## Addendum-01

**SB840 Wiekamp Hall - Restroom Remodel - IU# 20222221**

**Indiana University  
South Bend, Indiana**

Addendum Number One

**1** PARTIAL DEMOLITION FIRST FLOOR PLAN - NORTH RESTROOM  
3/8" = 1'-0"

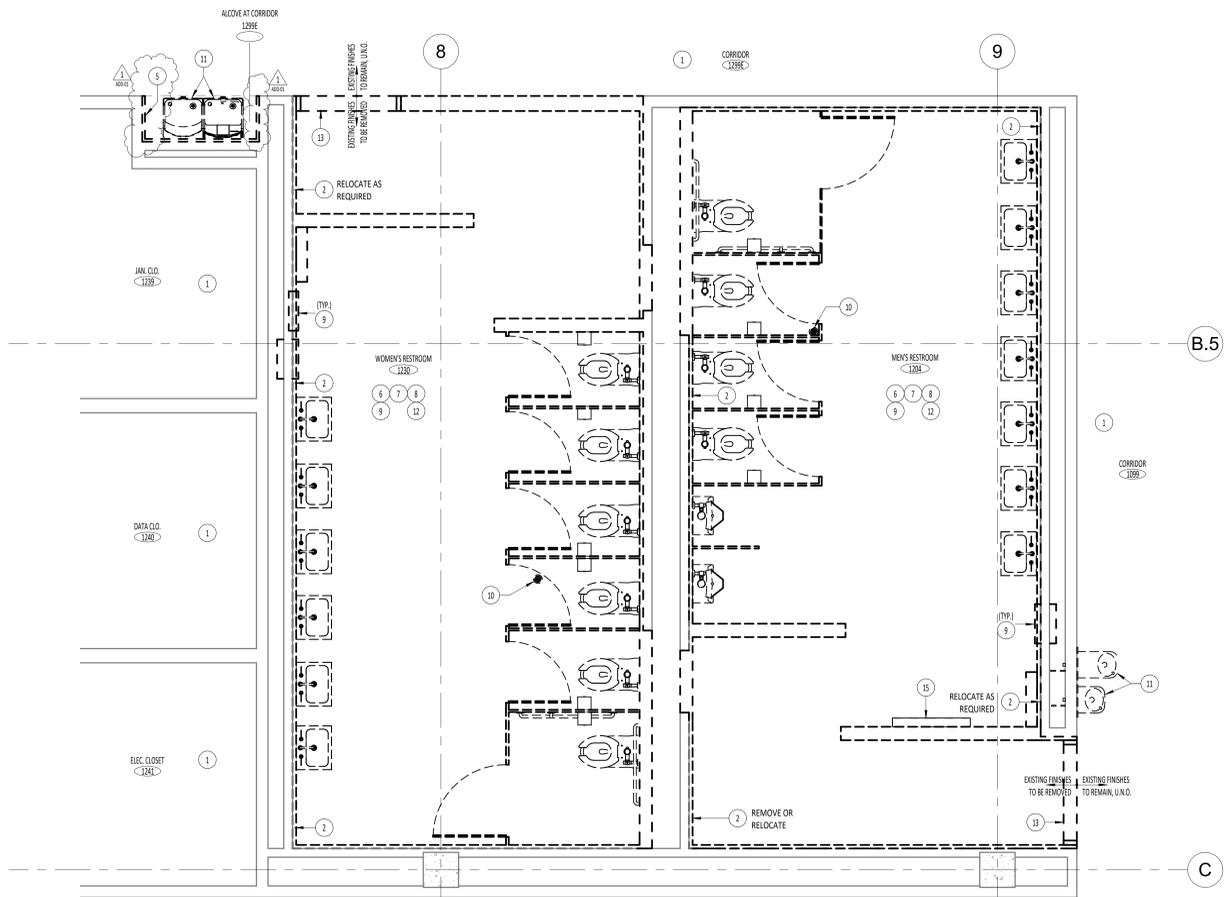
- 1.02 Reference:** Revised architectural sheet A1.1 - PARTIAL FIRST FLOOR DEMOLITION PLAN - NORTH RESTROOM with revision date 25 February 2026.
- A. Clarification:** Detail 1/A1.1 was revised to show larger extent for demolition work at corridor alcove where drinking fountain is located. Demolition Note #5 was added to identify scope of work at corridor alcove.

**1** PARTIAL DEMOLITION FIRST FLOOR PLAN - SOUTH RESTROOM

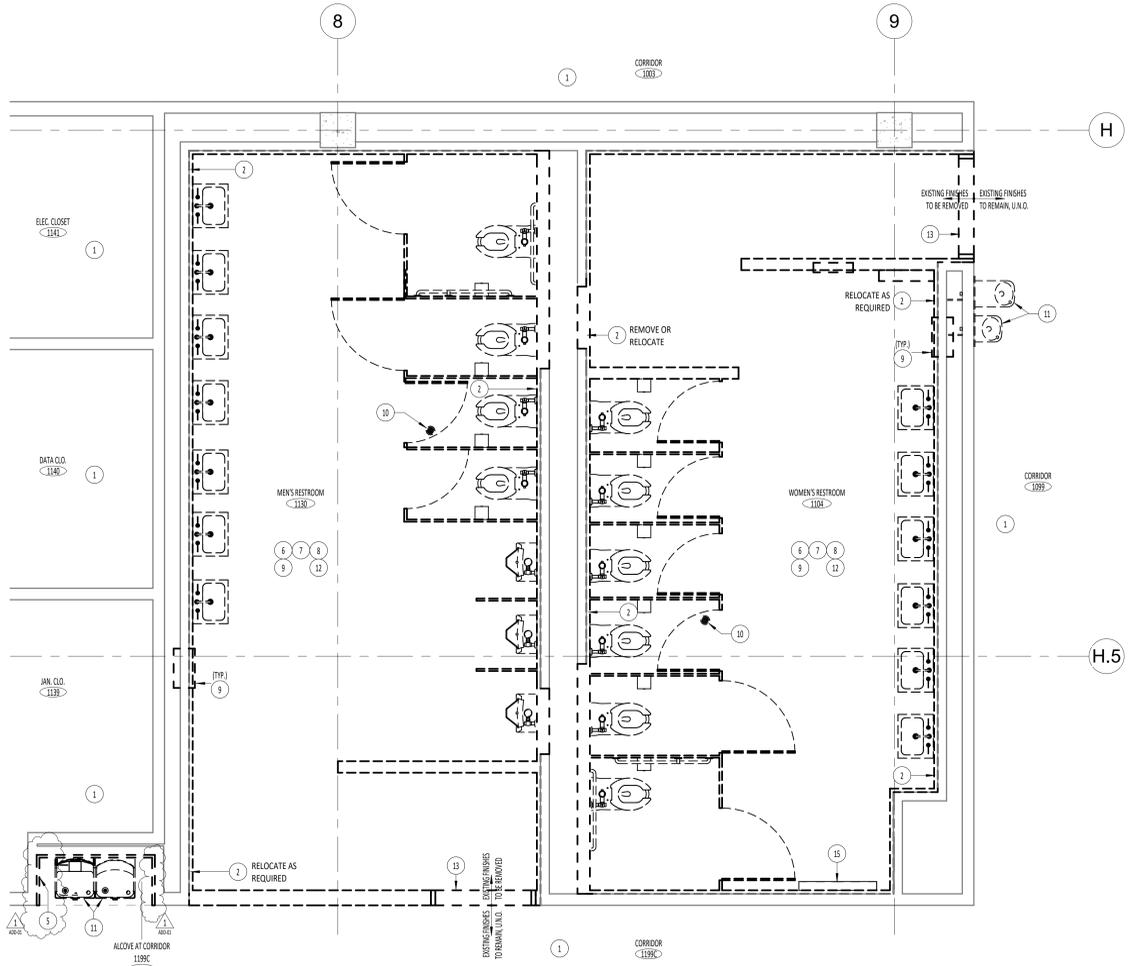
- 1.03 Reference:** Revised architectural sheet A1.2 - PARTIAL FIRST FLOOR DEMOLITION PLAN - SOUTH RESTROOM with revision date 25 February 2026.
- A. Clarification:** Detail 1/A1.2 was revised to show larger extent for demolition work at corridor alcove where drinking fountain is located. Demolition Note #5 was added to identify scope of work at corridor alcove.

13 ALCOVE AT CORRIDOR 1299E - SOUTH  
IE  
1/2" = 1'-0"

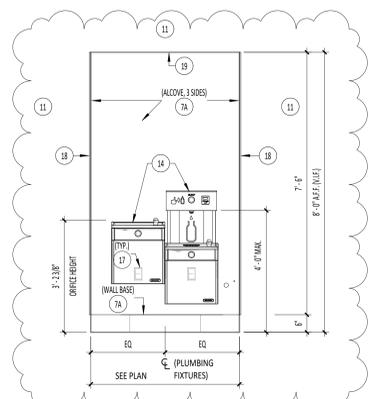
- A. **Clarification:** Detail 13/A4.0 was revised to show larger extent of new wall tile, wall base, and corner guards at drinking fountain alcove/recess. Interior Elevation Notes #18 and 19 were added.

**SB840 WIEKAMP HALL - RESTROOM REMODEL**  
**INDIANA UNIVERSITY SOUTH BEND - IU#20222221**  
**1700 E Mishawaka Ave, South Bend, IN 46615**  
**FINISH SCHEDULE AND DETAILS**

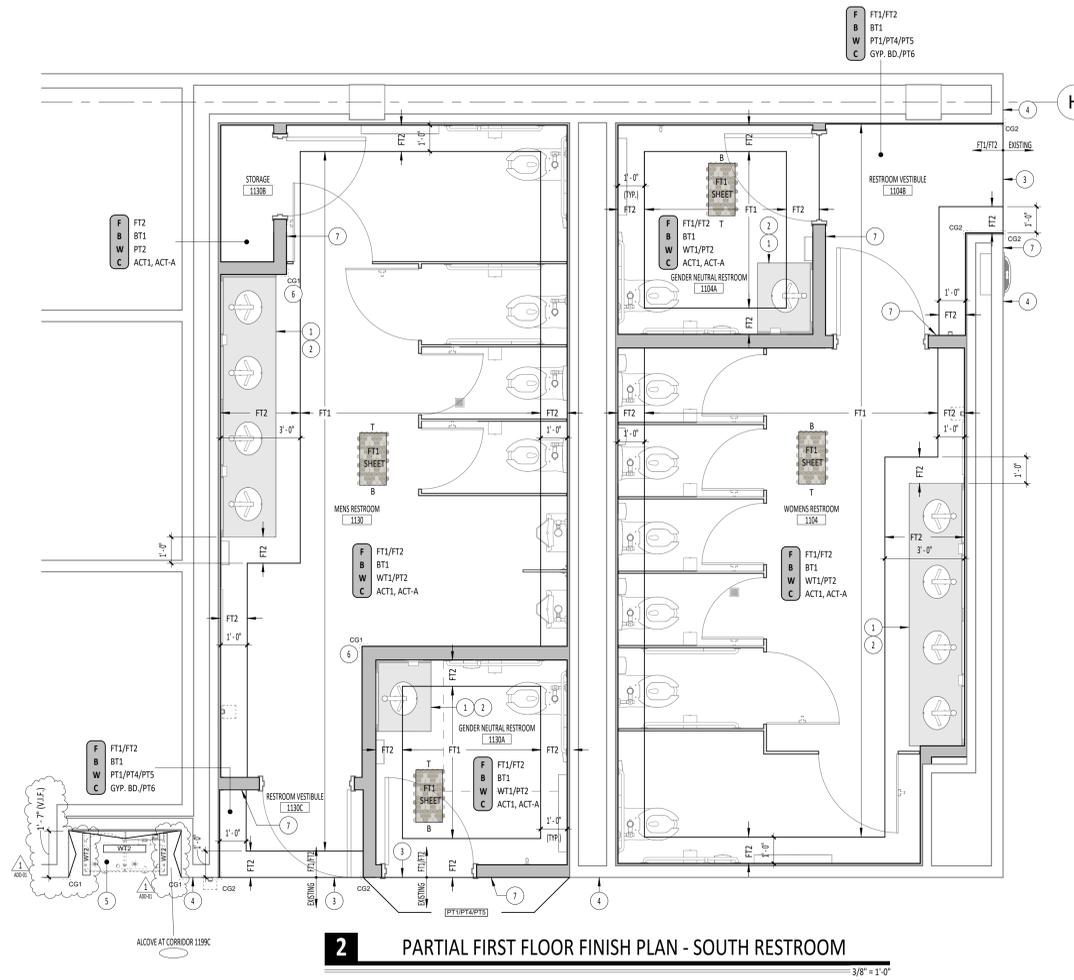
- 1.06 **Reference:** Revised interior design sheet FO.0 – FINISH SCHEDULE AND DETAILS with revision date 25 February 2026.
- A. **Clarification:** The Finish Schedule was revised to change the wall finish product WT2, Porcelain Wall Tile to be Marazzi Illusionist IL50 Magical (for wall finish) and IL48 Smoke (for wall base). This resulted after HHAЕ, the Architect, has been informed that the previously specified wall finish product WT2 (Morello Collection Random Mosaic Amber MMO4) has been discontinued by the manufacturer.

- 1.09 **Reference:** Contractor Question: *My Daltile representative has informed me that Restroom Field Tile (FT-1) Keystone Custom 2" Hexagon Pattern: Shamrock has been Discontinued. Can you please contact the Architect and owner and advise them a new selection will need to be made. **Additional statement by Contractor:** Update on the previous email. "I have just been notified by Daltile that (FT-1) Custom 2" Hex Pattern is still Discontinued, but Daltile will make it as a Special Custom Made-to-Order Pattern with a Lead time of [10-12 Weeks.]" Please confirm tile intentions.*

- A. **Clarification:** The Contractor shall have the option to either order the specified floor tile products FT1 and FT2 from Daltile as custom order products, or to order approved-as-equal, domestically sourced, floor tile products from another manufacturer. Refer to revision in Finish Schedule on sheet FO.0 [enclosed].

**1** PARTIAL FIRST FLOOR FINISH PLAN - NORTH RESTROOM  
3/8" = 1'-0"

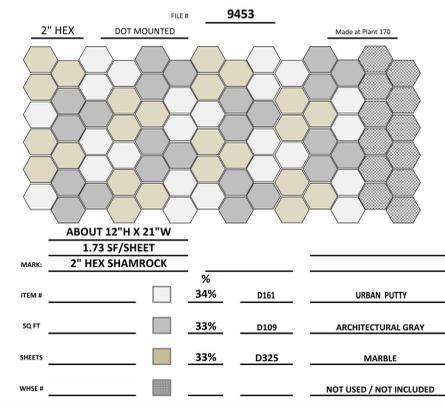
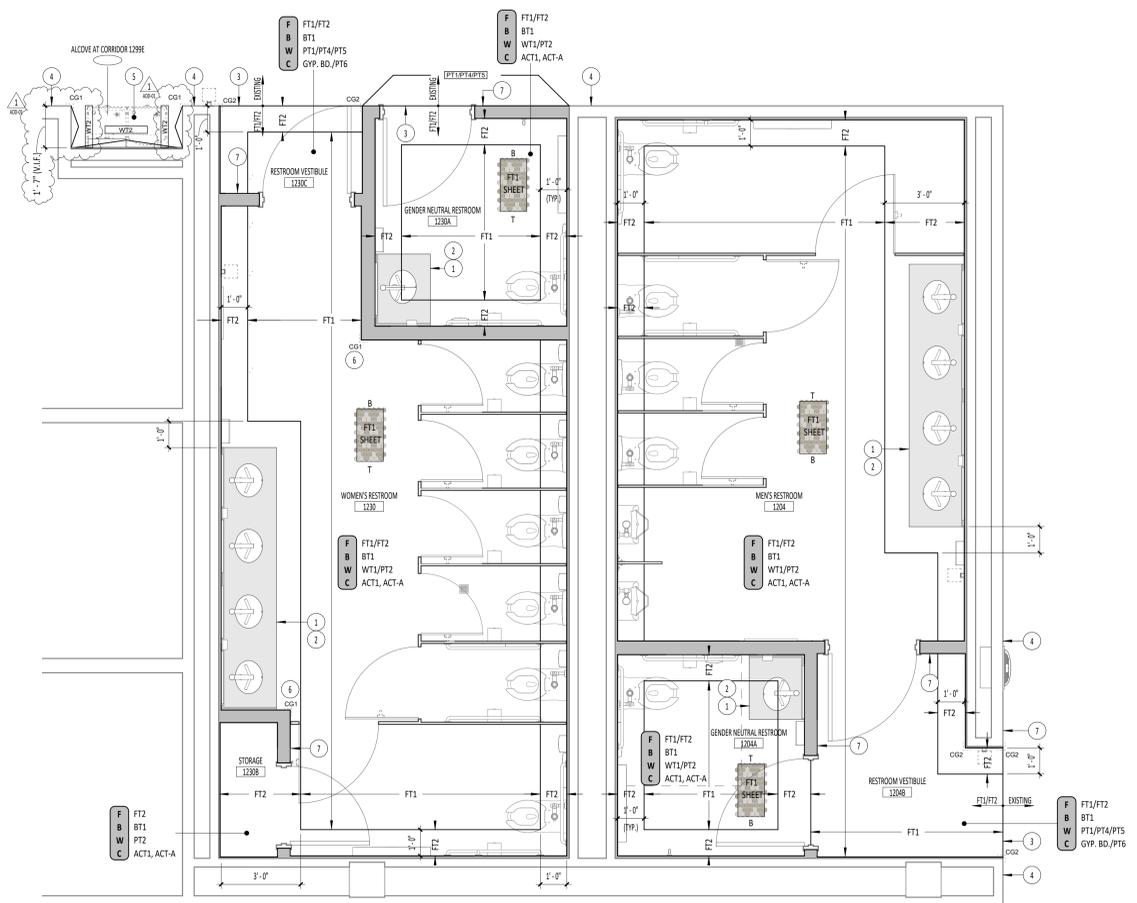
- 1.07 **Reference:** Revised interior design sheet F1.0 – PARTIAL FIRST FLOOR FINISH PLANS with revision date 25 February 2026.
- A. **Clarification:** Details 1 and 2/F1.0 were revised to show the change in wall finishes for the alcove/recess areas along corridors 1199C and 1299E. The new wall finishes have been changed to wall finish WT2 on all sides and to corner guards CG1 at outside corners.
